SUBJECT: Supplement to the Application for Certification
Rio Mesa Solar Energy Generating Facility (11-AFC-4)

Response to Data Adequacy Review of the APPLICATION FOR CERTIFICATION for the Rio Mesa Solar Electric Generating Facility

(11-AFC-04)

Response to Data Adequacy Review

RIO MESA
SOLAR ELECTRIC GENERATING FACILITY
RIO MESA UNIT 1
UNDERGROUND GAS LINE
LOCATION PLAN

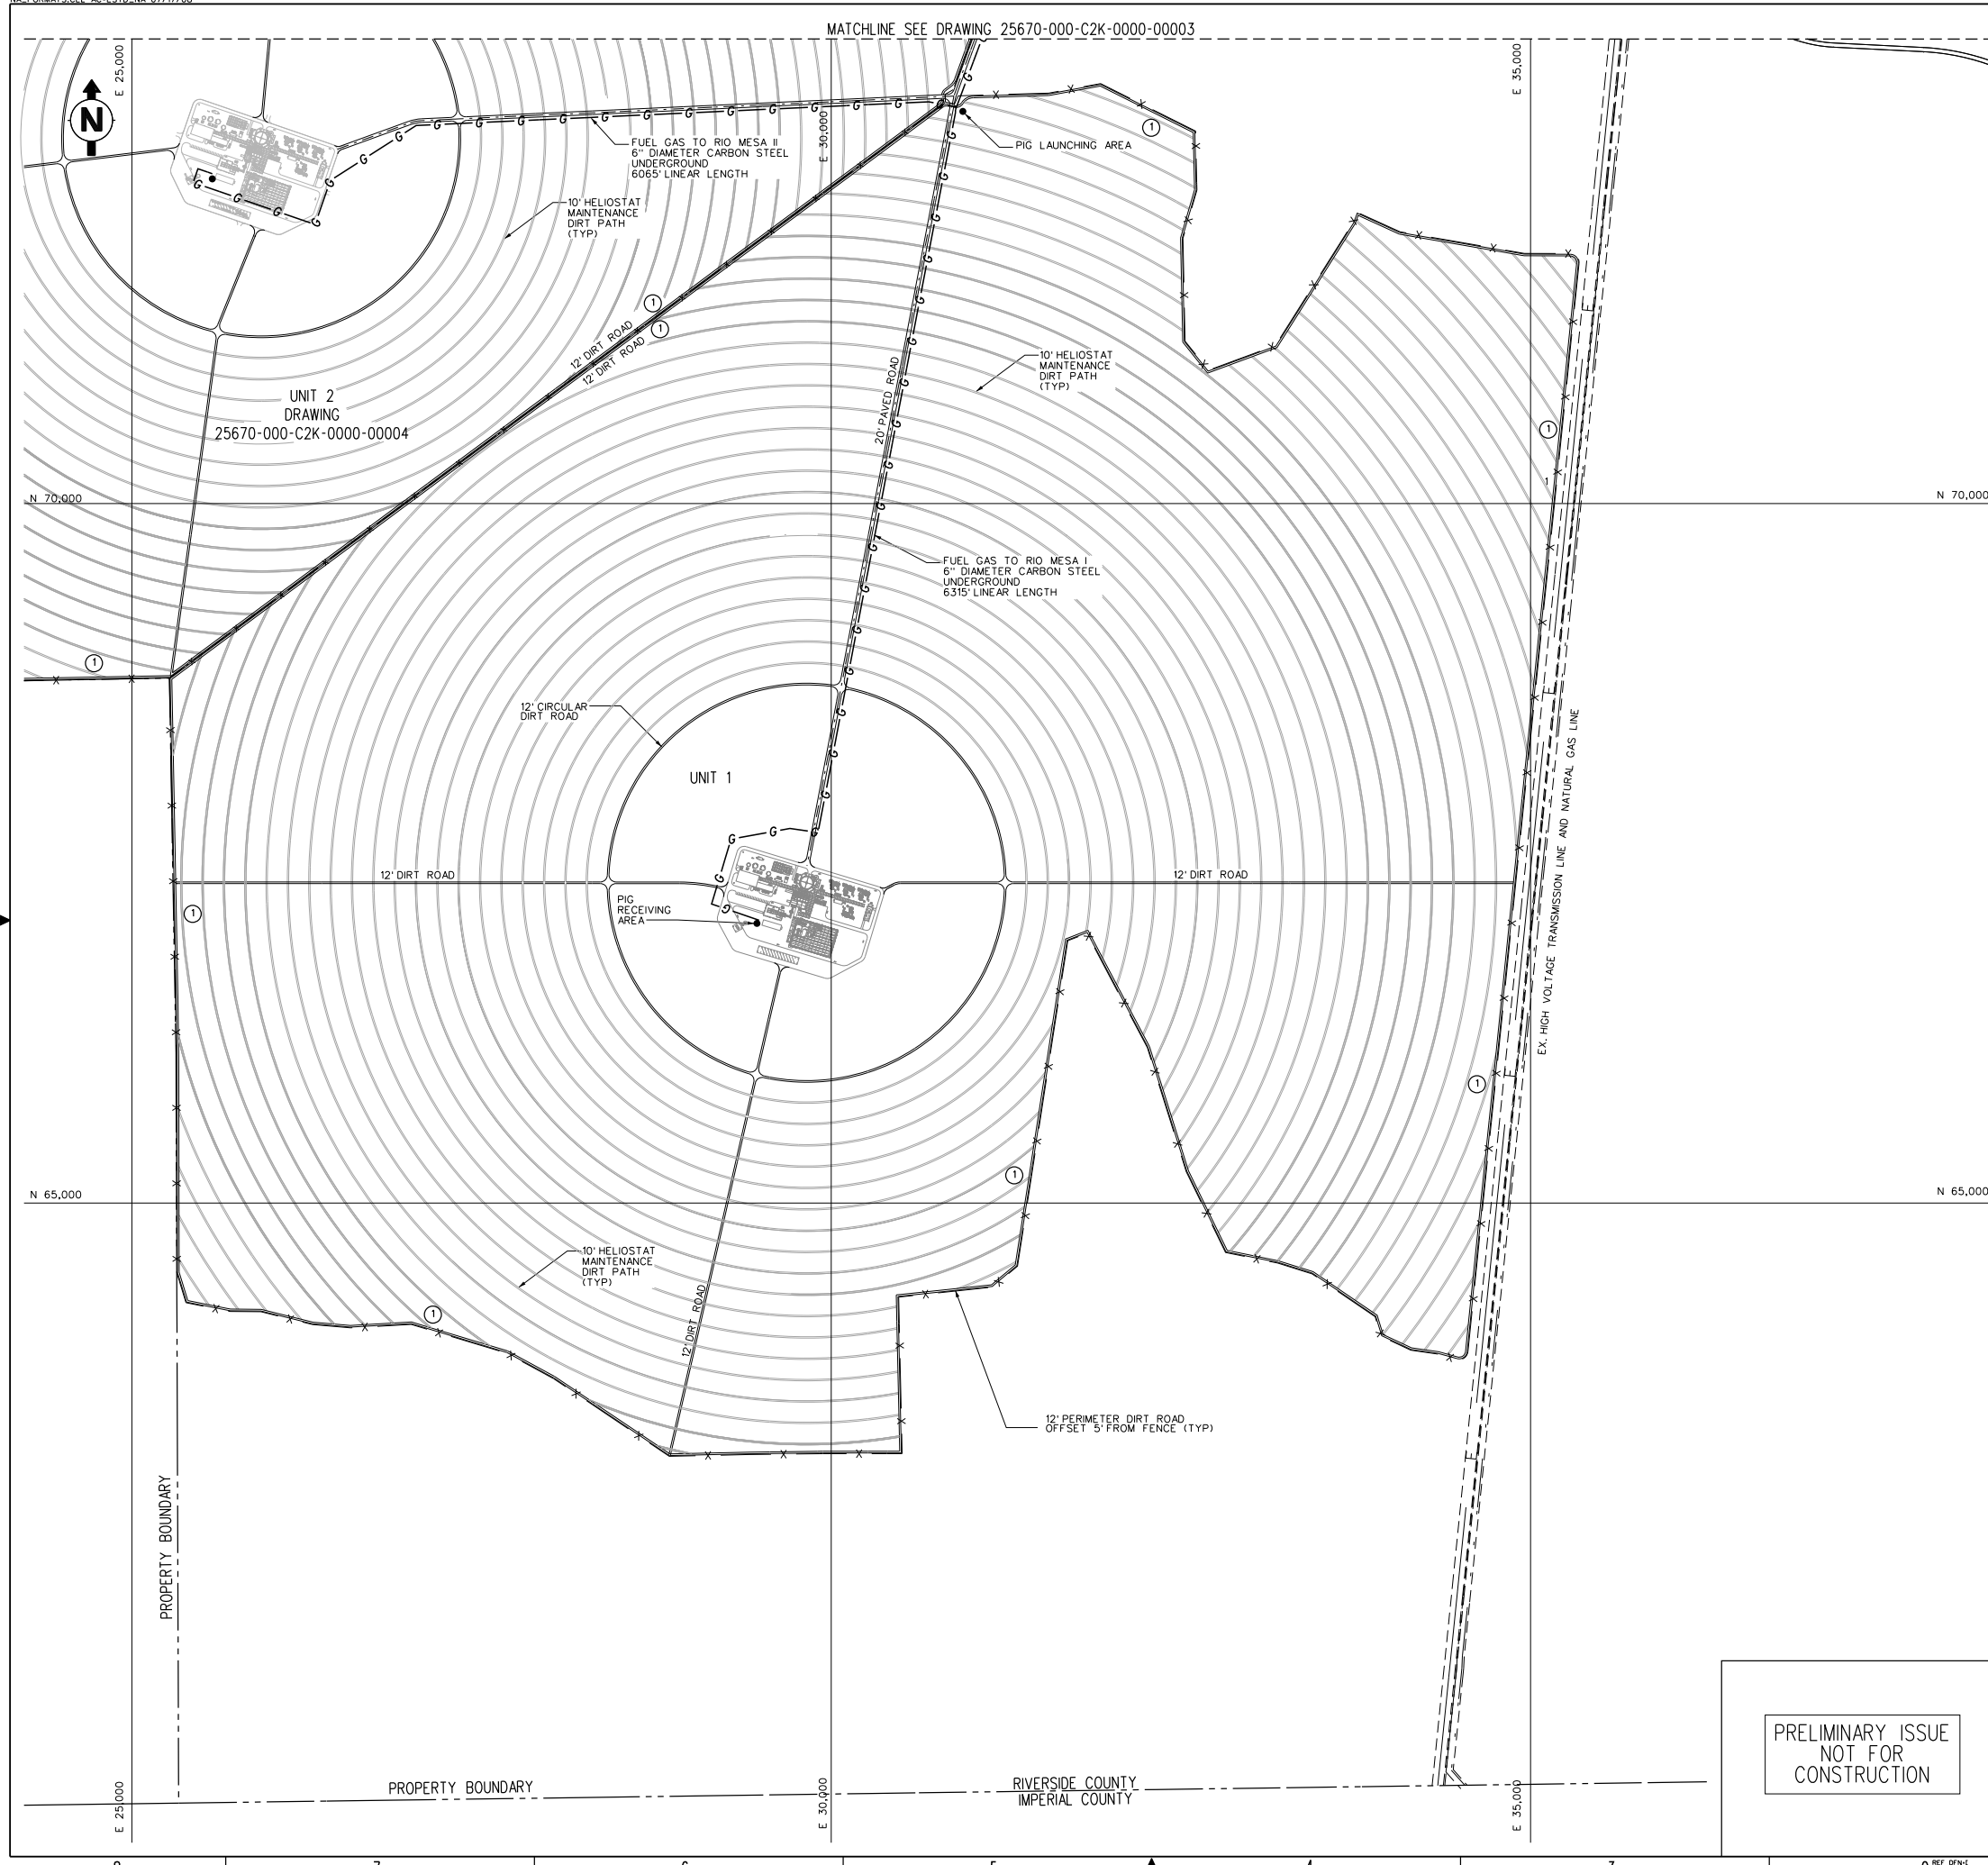
Please provide a description of the length and location of the proposed gas lines from each power block to the proposed metering station as well as map showing the proposed locations of the gas lines.

Response: The natural gas supply pipelines from the proposed metering station will all be buried until they reach the power blocks of the three individual plants. The individual natural gas supply for Rio Mesa Solar III will start from the tee off of the common pipeline (see Figure 2-4) and follow the main access road to the power block. The individual natural gas supply for Rio Mesa Solar II will start from the tee off of the common (to Plants RMS I and RMS II) gas pipeline (see Figure 2-3) and follow the main access road to the power block. The individual natural gas supply for Rio Mesa Solar I starts from where RMS II's gas supply pipeline tees off and then follows the main access road to the power block (See Figure 2-1). The specific gas pipeline runs will be as follows:

Gas Pipeline to Rio Mesa Solar I (Figure 2-1). This underground leg is a natural gas supply pipeline for Rio Mesa I only. It follows the main access road from the point where Rio Mesa Solar II natural gas pipeline tees off and terminates above ground in the power block of Rio Mesa Solar I. The length of this pipeline is approximately 6,315 feet.

TYPICAL VIEW OF POWER BLOCK FROM THE NORTHWEST FACING SOUTHEAST
RIO MESA SOLAR
ELECTRIC GENERATING FACILITY

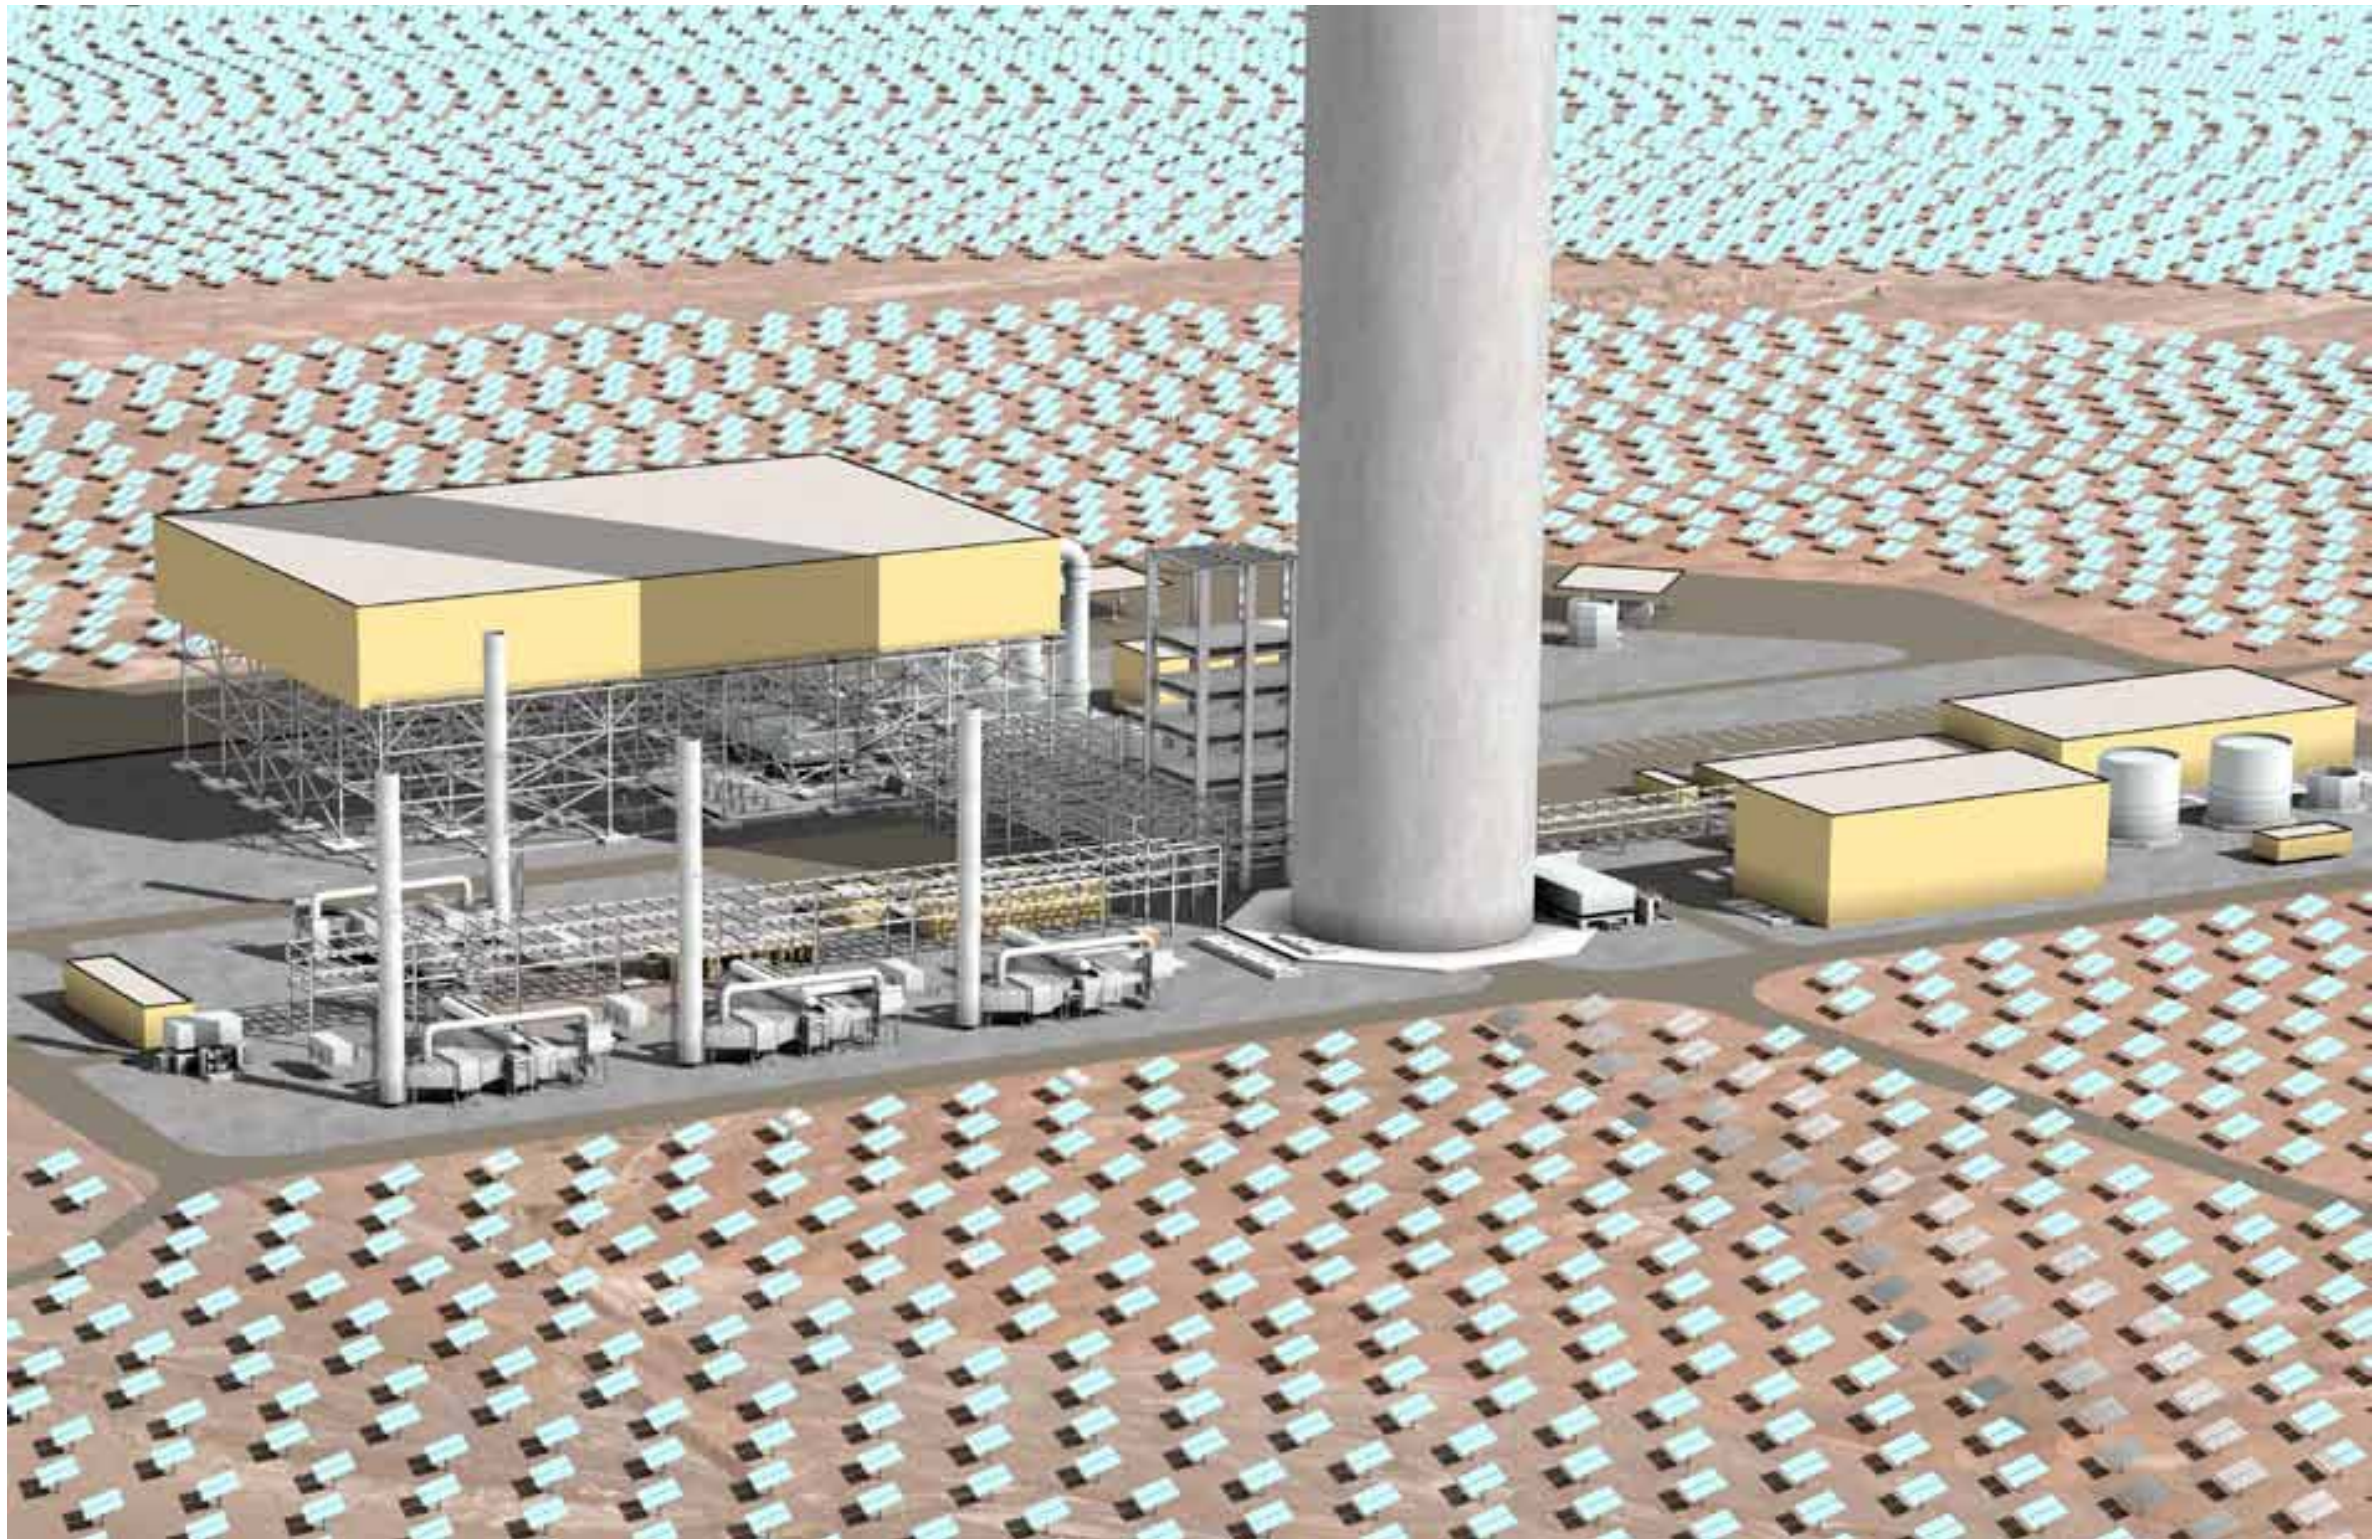
Provide an artist's rendering representative of one of the power blocks and the surrounding facilities/components.

Response: The attached figures represent typical close up views of the power block and surrounding facilities/components at Rio Mesa SEGF.
